Serpent is offering a free replacement program on the wishbones of the Cobra SRX8 buggy.

Updated wishbones are:

FRONT WISHBONES

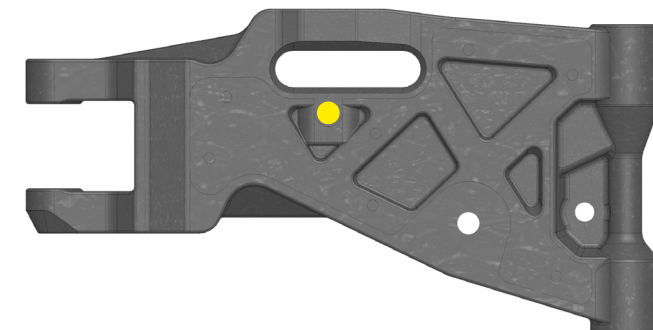
With the currently wishbones, especially the front ones broke under severe impact, but for our quality standards they broke too quick. To warranty our high quality image we decided to do a full replacement program of the front and rear wishbones.

The updated wishbones are beefed up in some locations and they are now made in a softer material which has more flex than before, to create more overall grip. By using the moulded or carbon inserts, top and or bottom, the arm can be made stiffer as needed.

At the same time we also changed the position of the set screw (see in yellow in the right pictures) that keeps the spring-steel shock-bolt in position. It's been moved more to the inside of the arm. For this new shock-bolts are made with the groove closer to the end instead of at the front.
